LEVEL 2 CAPACITY CHECK RESPONSE

Site: Barnham Development Sites, Yapton Road, Barnham, West Sussex, PO22 0BL.

**Study into the Options for Foul Drainage Provision along Yapton Road,
Lidsey.**

STUDY INTO THE OPTIONS FOR
FOUL WATER DRAINAGE PROVISION FOR
BARNHAM DEVELOPMENT SITES

Figure 2- Proposed Improvements – Foul system

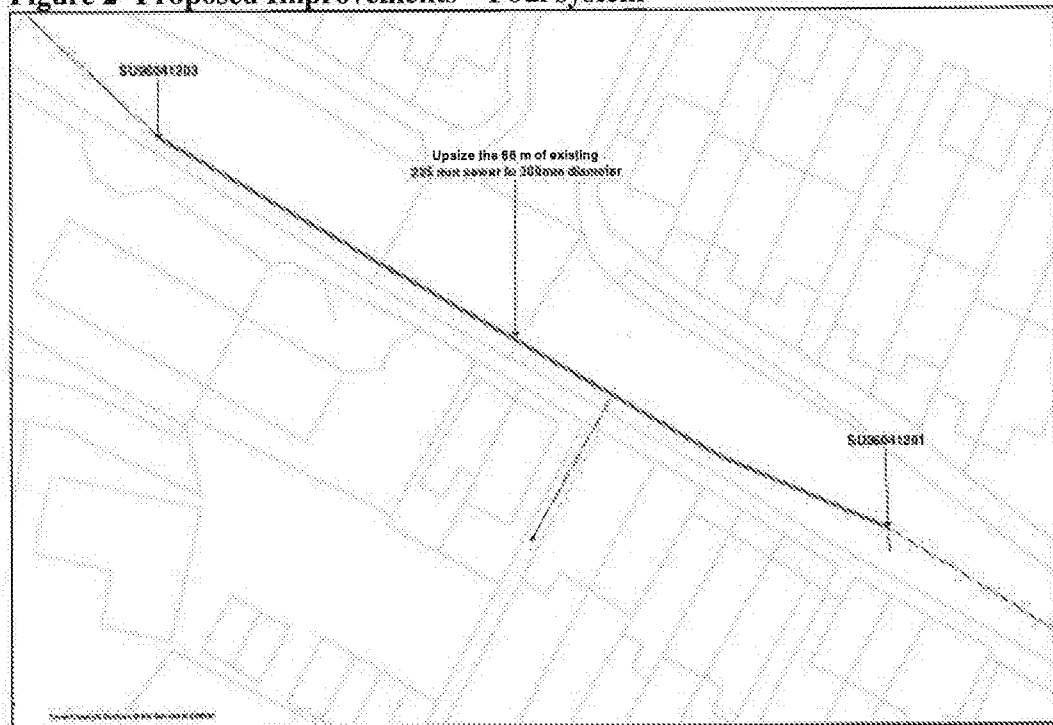
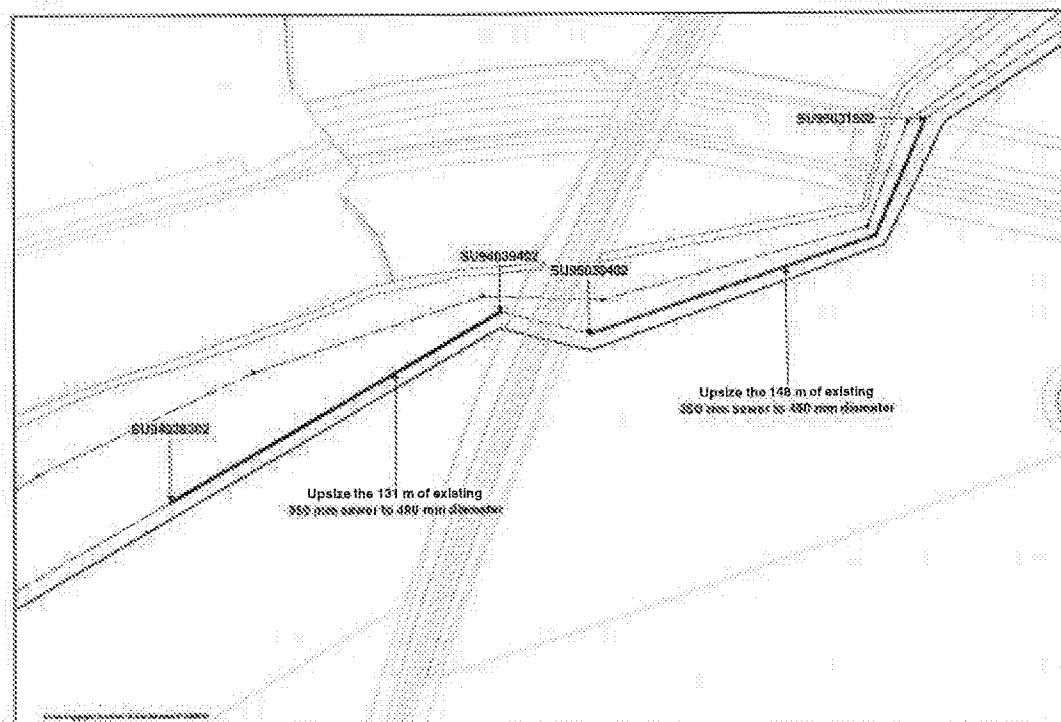
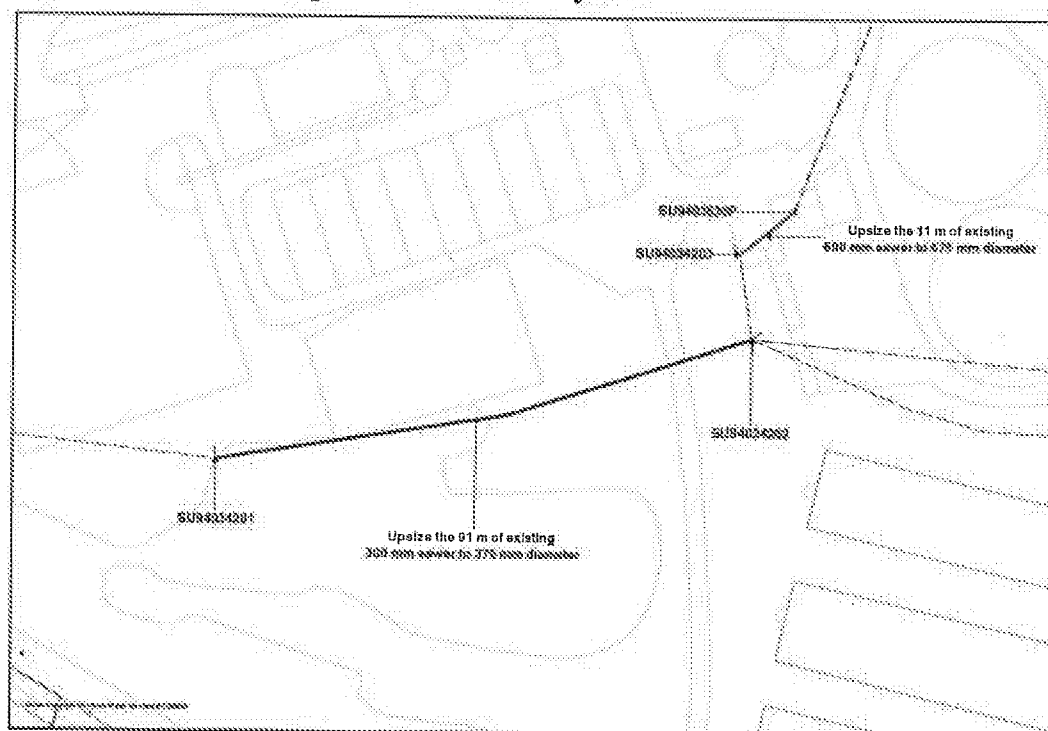
There is currently inadequate capacity within the local foul sewerage network to accommodate a flow of 6.7 l/s at manhole reference SU96043101. The proposed development would increase flows to the local network and as a result existing properties and land may be subject to a greater risk of flooding. Additional off-site sewers or improvements to existing sewers will be required to provide sufficient capacity to service the proposed development as indicated in Figure 2, 3 & 4 and Table 2.

U/S Manhole	D/S Manhole	Sewer Diameter (mm)		Avg. Depth (m)	Length (m)
		Existing	Proposed		
SU96041201	SU96041203	225	300	2.3	68
SU95031502	SU95030402	350	450	1.5	148
SU94039402	SU94038302	350	450	1.6	131
SU94034201	SU94034202	300	375	5.1	91
SU94034203	SU9403530P	600	675	-	11

Figure 2- Proposed Improvements – Foul system

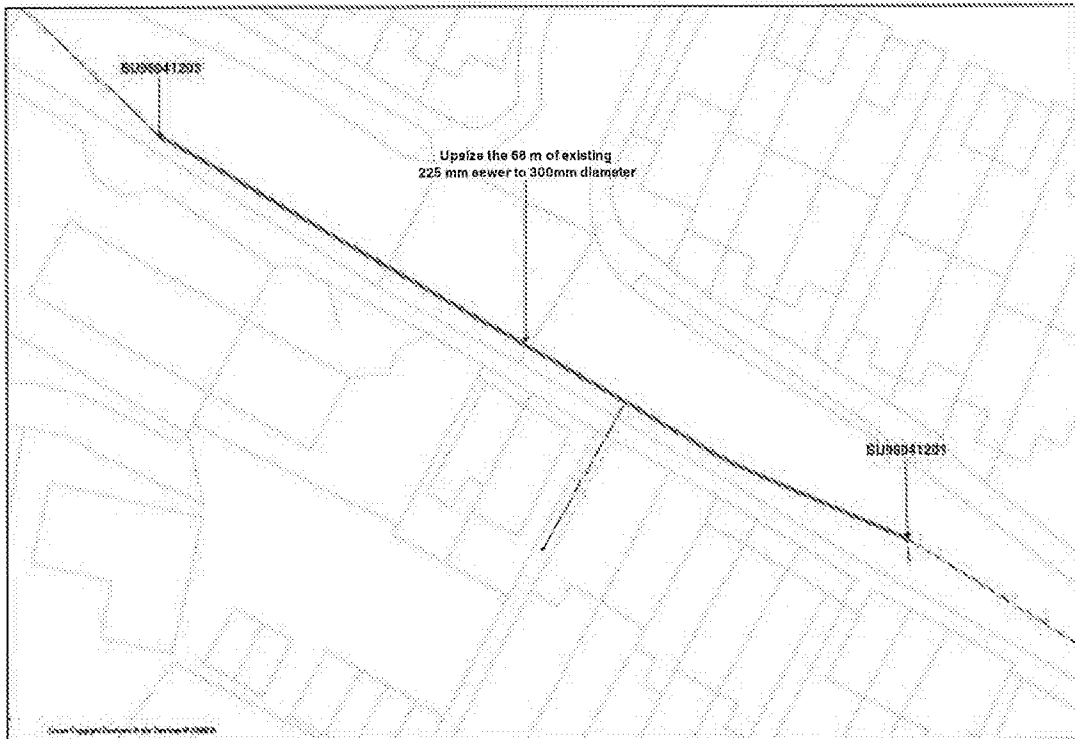
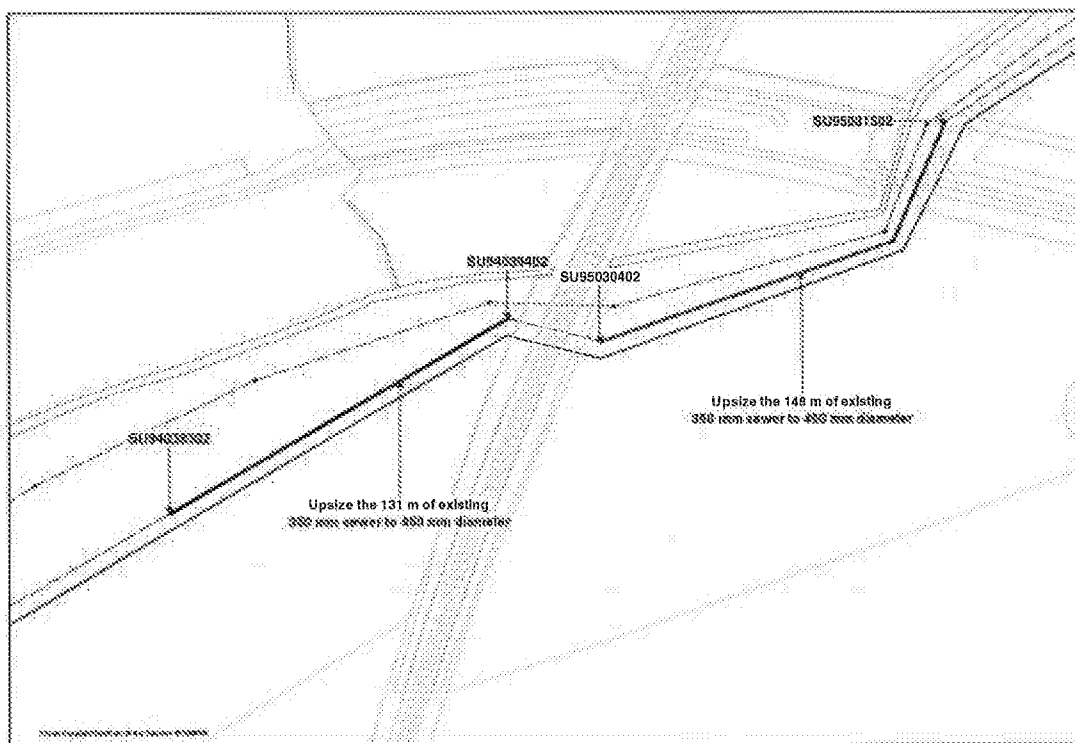
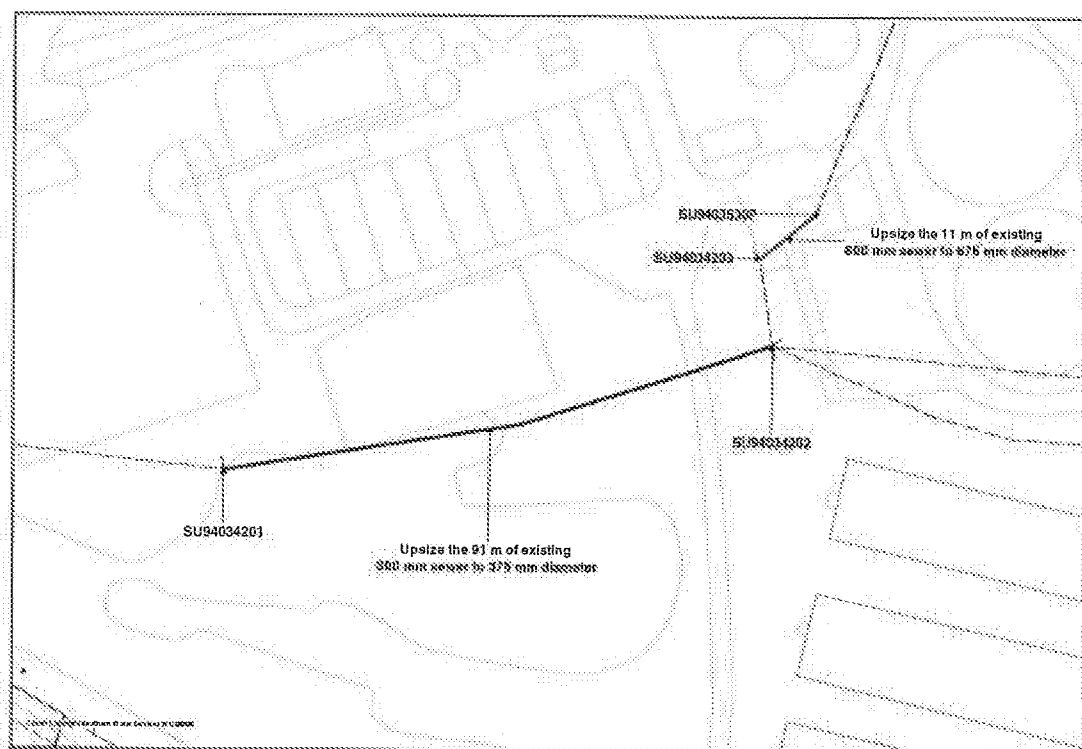
There is currently inadequate capacity within the local foul sewerage network to accommodate a flow of 6.7 l/s at manhole reference SU96043101. The proposed development would increase flows to the local network and as a result existing properties and land may be subject to a greater risk of flooding.

Additional off-site sewers or improvements to existing sewers will be required to provide sufficient capacity to service the proposed development as indicated in Figure 2, 3 & 4 and Table 1.

U/S Manhole	D/S Manhole	Sewer Diameter (mm)		Avg. Depth (m)	Length (m)
		Existing	Proposed		
SU96041201	SU96041203	225	300	2.3	68
SU95031502	SU95030402	350	450	1.5	148
SU94039402	SU94038302	350	450	1.6	131
SU94034201	SU94034202	300	375	5.1	91
SU94034203	SU9403530P	600	675	-	11
